Item Name: AS350/AS355 Heli-Utility-Basket™ Short Version - Fits LH or RH

DART SERVICE INSTRUCTION
TO AMEND INSTALLATION INSTRUCTIONS D350-607-1 REV. A AND
INSTRUCTIONS FOR CONTINUED AIRWORTHINESS ICA-D350-607 REV. 6
REF CANADIAN STC: SH94-14
REF FAA STC: SR00213NY
REF EASA STC: 10016996

A	NEW ISSUE	MB	14.09.25
REV.	DESCRIPTION	BY	DATE
DESIGN		DART AEROSPACE LTD	
DRAWN		HAWKESBURY, ONTARIO, CANADA	
CHECKED		DRAWING NO.	REV. A
MFG. APPR.	N/A	DSI 9709	SHEET 1 OF 4
APPROVED		TITLE	SCALE
DE APPR.		PARTS LIST CORRECTION	NTS
DATE	14.09.25	COPYRIGHT © 2014 BY DART AEROSPACE LTD THIS DOCUMENT IS PRIVATE AND CONFIDENTIAL AND IS SUPPLIED ON THE EXPRESS CONDITION THAT IT IS NOT TO BE USED FOR ANY PURPOSE OR COPIED OR COMMUNICATED TO ANY OTHER PERSON WITHOUT WRITTEN PERMISSION FROM DART AEROSPACE LTD.

Figure 2 - High Skid Installation
(LH installation shown, RH opposite)

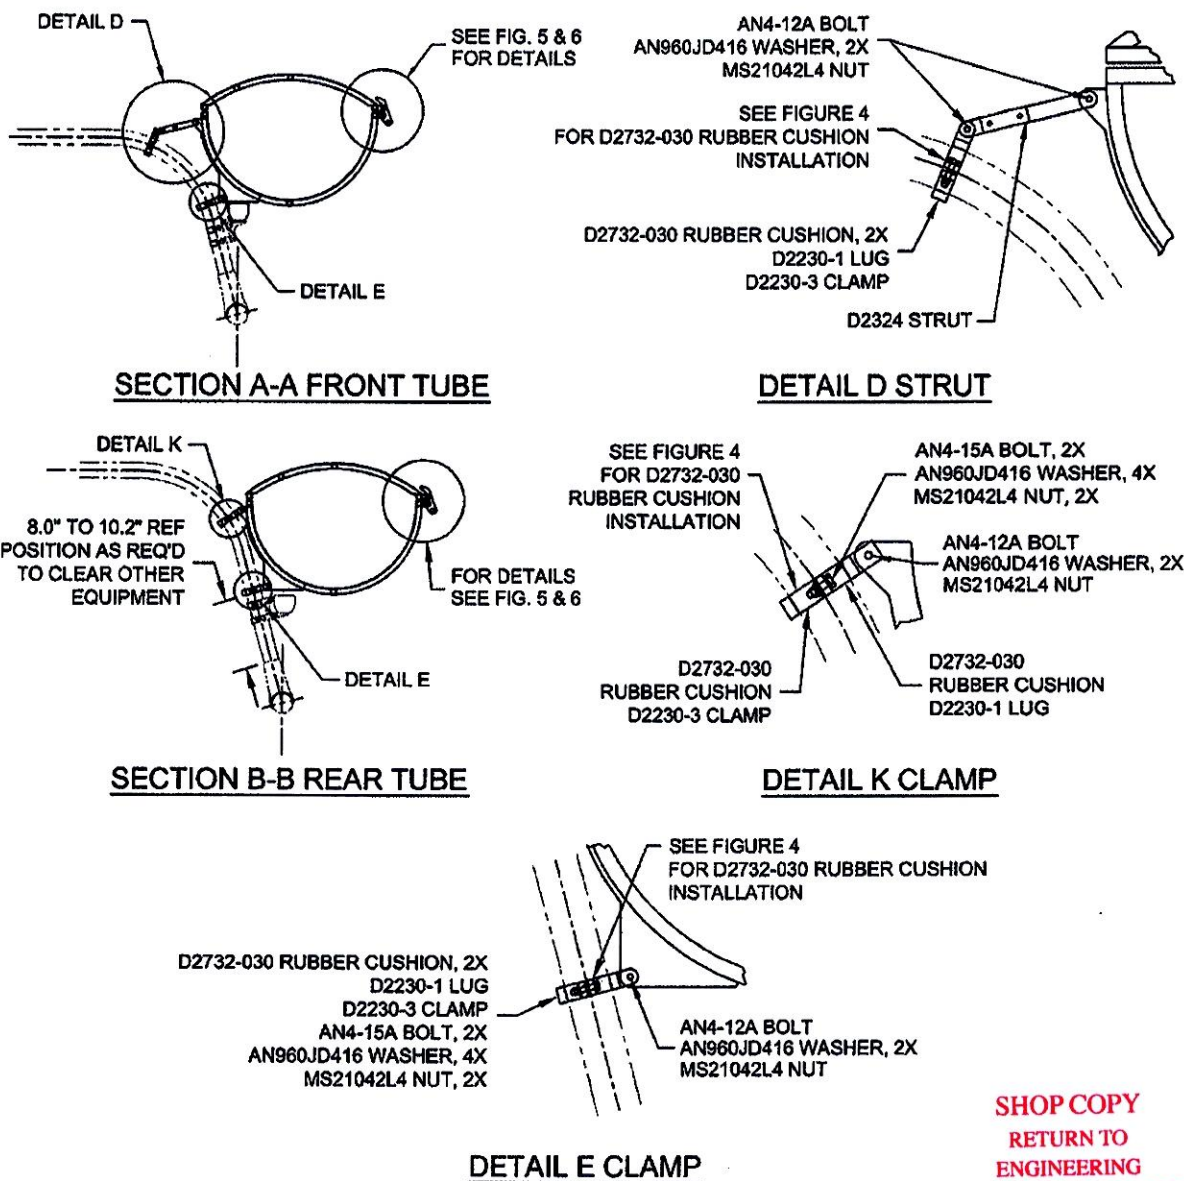
- 2.1 Sheet 2 of this DSI amends Figures 2 of D350-607-1 Rev. A and 25-1 of ICA-D350-607 Rev. 6;
- 2.2 Sheet 3 of this DSI amends Figures 3 of D350-607-1 Rev. A and 25-2 of ICA-D350-607 Rev. 6;
- 2.3 Sheet 4 of this DSI amends the Parts Lists of Installation Instructions D350-607-1 Rev. A (Sections 6.1 and 6.2) and ICA-D350-607 Rev. 6 (Sections 25.27.1 and 25.27.2).

**FIGURE 1: CHANGES TO FIGURE 2 OF D350-607-1 REV. A
AND FIGURE 25-1 OF ICA-D350-607 REV. 6**

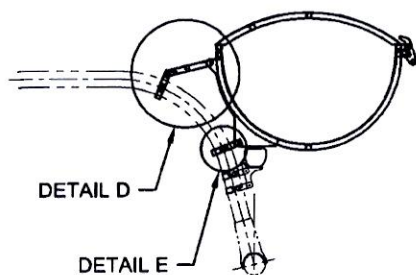
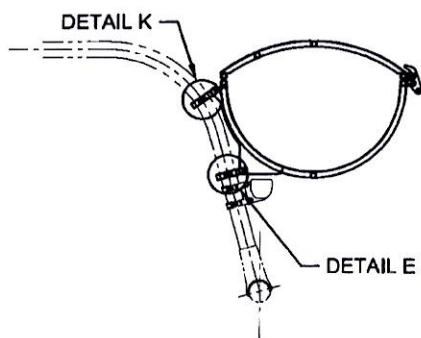
IS: AN4-15A BOLT
WAS: AN4-12A BOLT

IS: AN4-15A BOLT
WAS: AN4-12A BOLT

IS: AN4-15A BOLT
WAS: AN4-12A BOLT

**FIGURE 2: CHANGES TO FIGURE 3 OF D350-607-1 REV. A
AND FIGURE 25-2 OF ICA-D350-607 REV. 6**

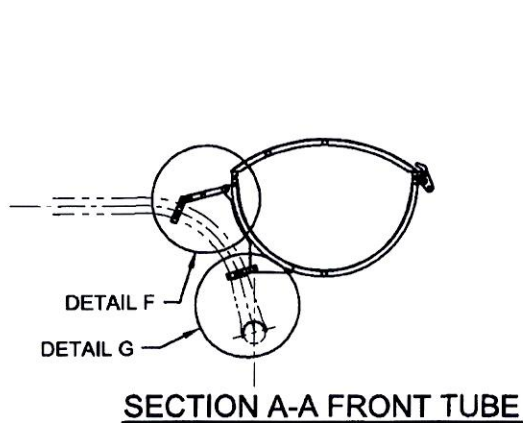
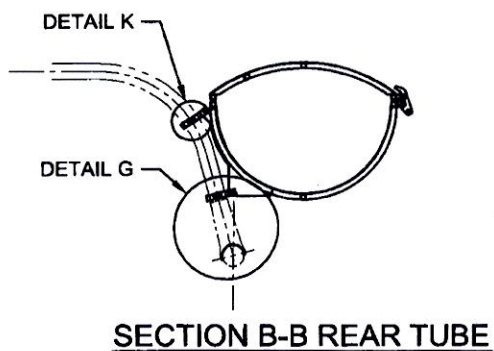
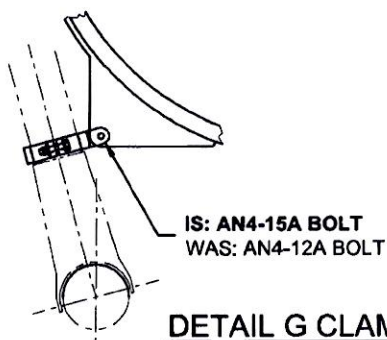
IS: AN4-15A BOLT
WAS: AN4-12A BOLT
